APPLICATION TO THE ZONING BOARD OF ADJUSTMENT

Denial Memorandum

Applicant: Matt and Amanda Lukof
Address: 35 Wardell Avenue, Rumson, New Jersey 07760
Block, Lot & Zone: Block 105, Lot 43, Zone R-4

Lukof Residence
Residential Addition & Renovation
35 Wardell Ave., Rumson, NJ 07760
Block 105 / Lot 43

1 SITE PLAN / ZONING DIAGRAM
A1 1" = 20'

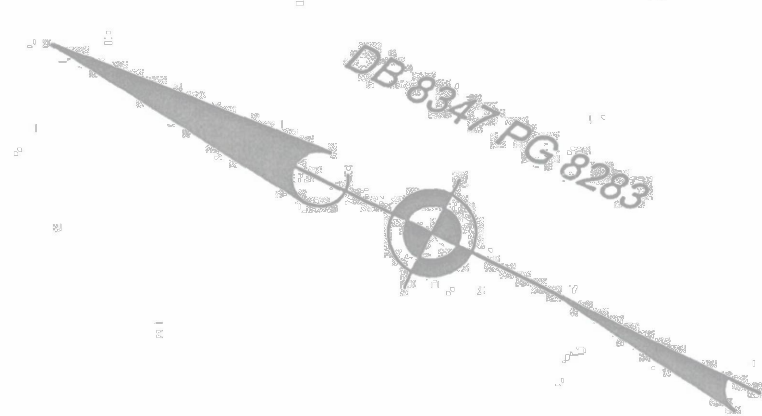
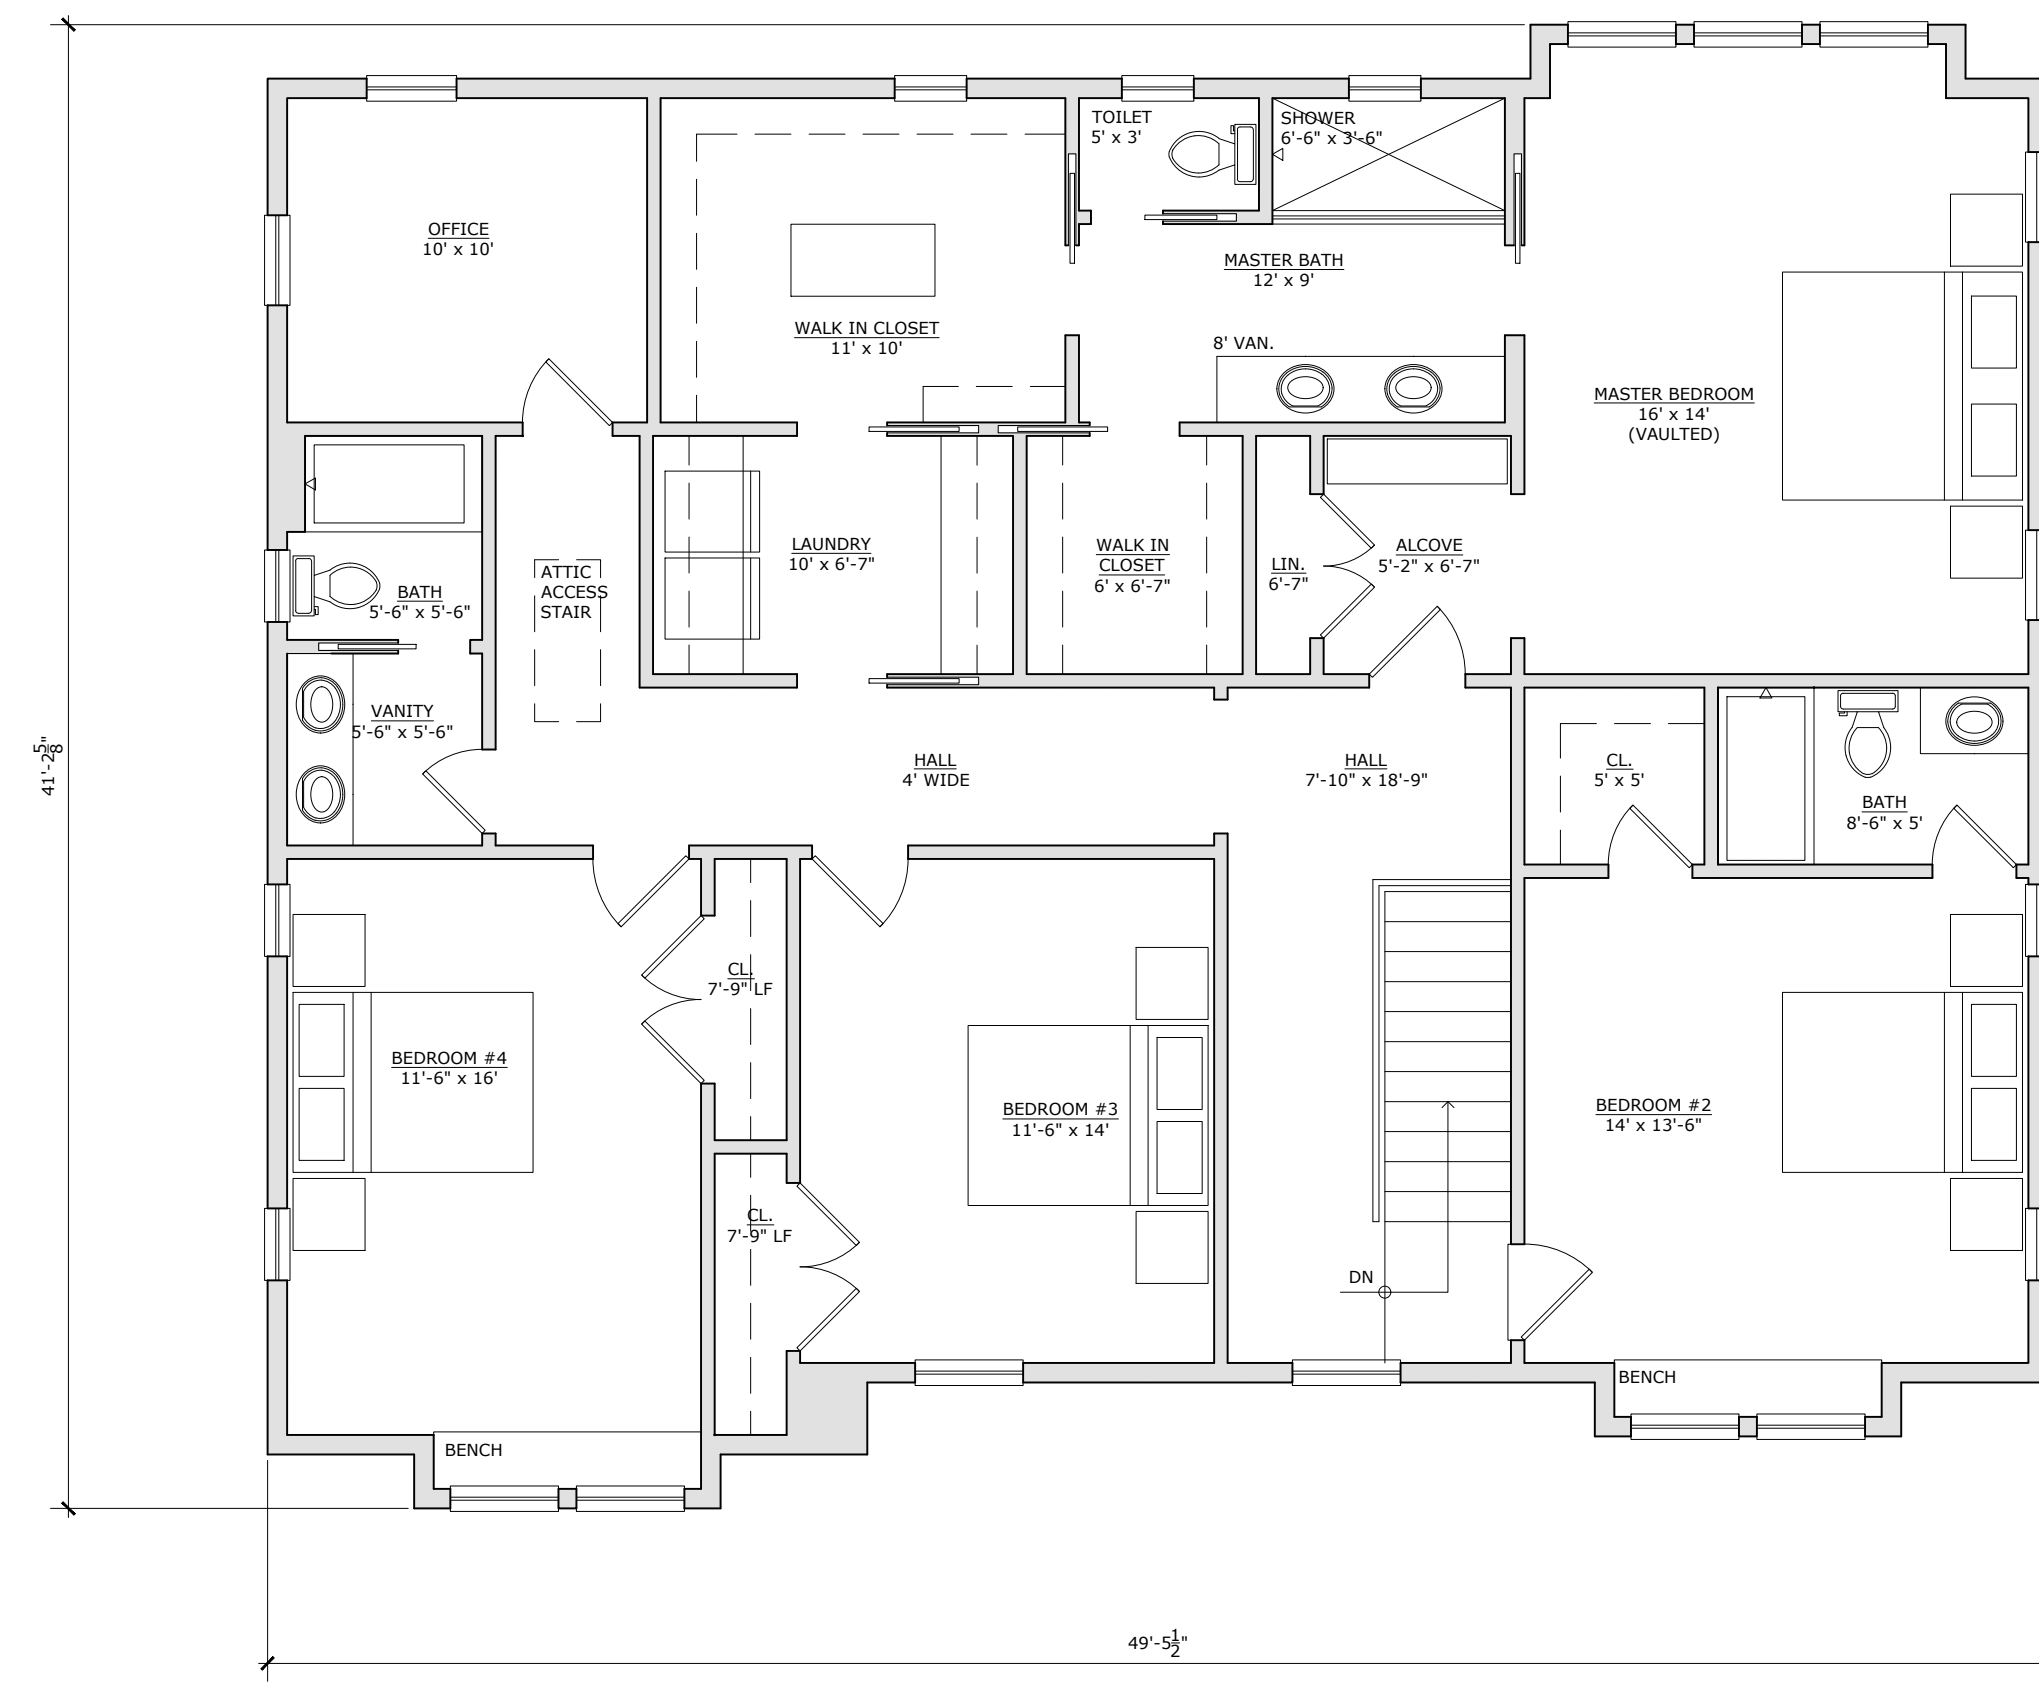
- Add the building envelope on proposed site plan.
- Correct the existing and proposed Front Yard Setback in the Zoning Chart.
- Correct the existing stories to 1.5 in the Zoning Chart.
